MCHJ/HS, MCHS-OS, MCHG2 Series

Appearance Change Notification

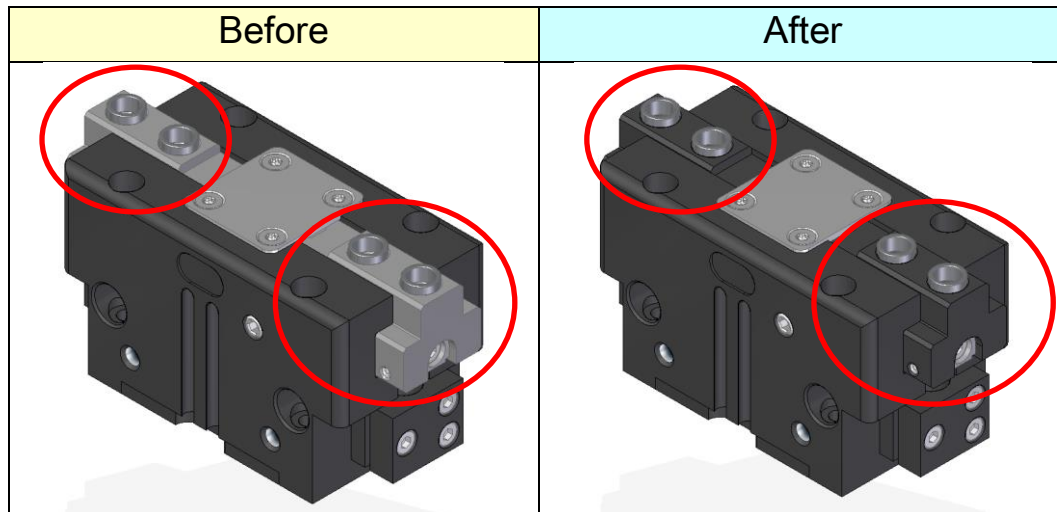
Optimize appearance.

3. Change descriptions

It will not affect usage, and will replace sequentially.
